**Response to comments on “High-resolution automated detection of headwater streambeds for large watersheds” Francis Lessard, Naïm Perreault, Sylvain Jutras**

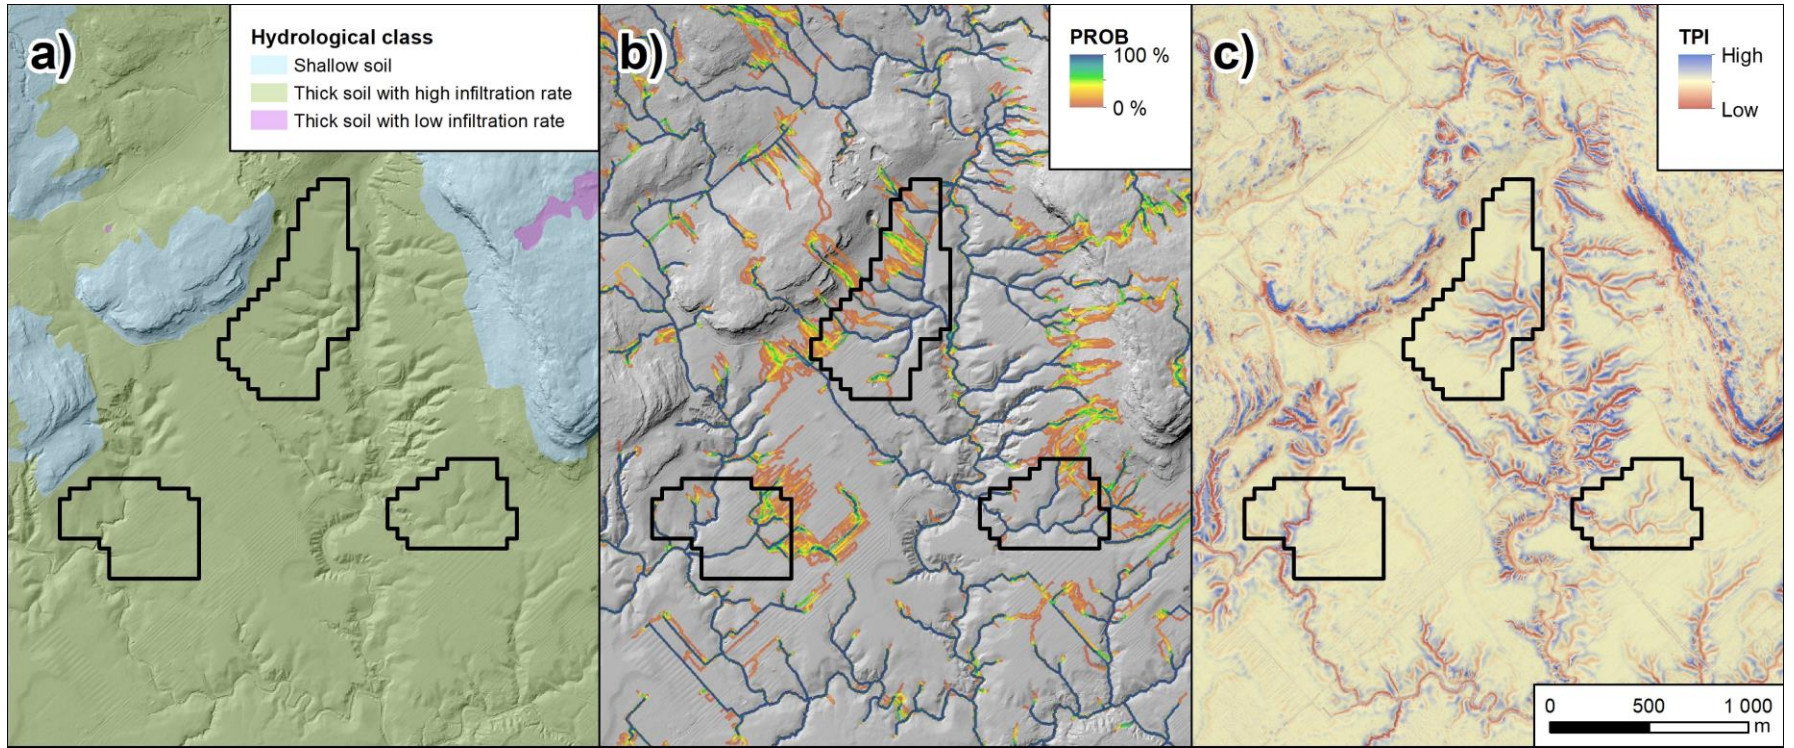
p. 8, line 146 (Figure 1): This figure could be improved, adding a legend to clarify what the red polygons represent (watersheds?) and adding a few labels for the main cities (e.g. Montreal), with also a label for the province of Ontario.

This sentence have been added : “Red polygons represent watersheds where field surveys were carried out.” This figure has been improved.

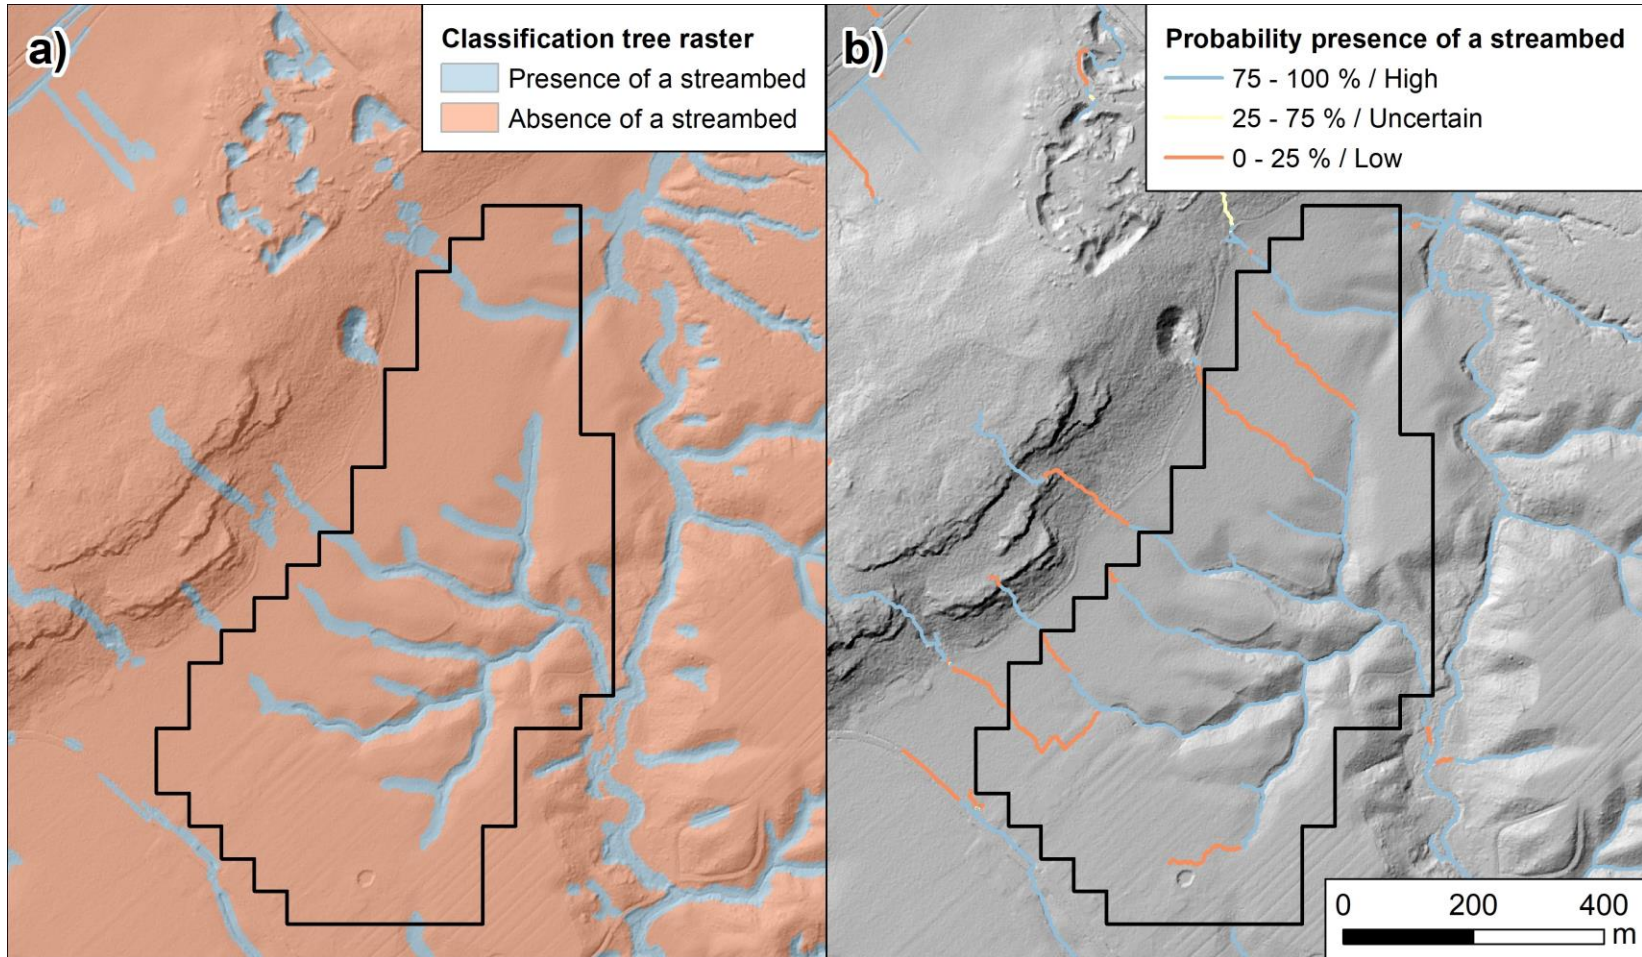
p. 10, lines 200-206: References on subsurface processes for streambed formation, and particularly their higher rate of incision, are needed as this explanation is not clear. Subsurface flow will affect the extent of contributing areas (saturated overland flow) and hysteresis (Jensen et al., 2019), but the link between these hydrological processes and streambed incision is not obvious. Channel incision, as noted by Wohl (2018), is more prevalent in arid to semiarid environments, or in karstic landscapes, which is not the geomorphological context of this study.

p. 11, lines 209-211: This is not obvious in the context of this study (see above comment).

The incision perceptible in our study area are made through longer process occurring since beginning of Holocene and are under canopy unlike in arid to semiarid environments. As noted in figure 3, drainage area are way more variable in the hydrological class “Thick soil with high infiltration rate” that other classes. This is due to the contribution of subsurface process for the creation of streambeds. Indeed, in this class, a certain number of stream are formed by water coming out of the ground, i.e. resurgences (larger number compared to other hydrological classes). A figure will be added in order to show the contribution of incision and TPI for this class. Furthermore, the figure 6 will me modified. The following territory will be used instead:
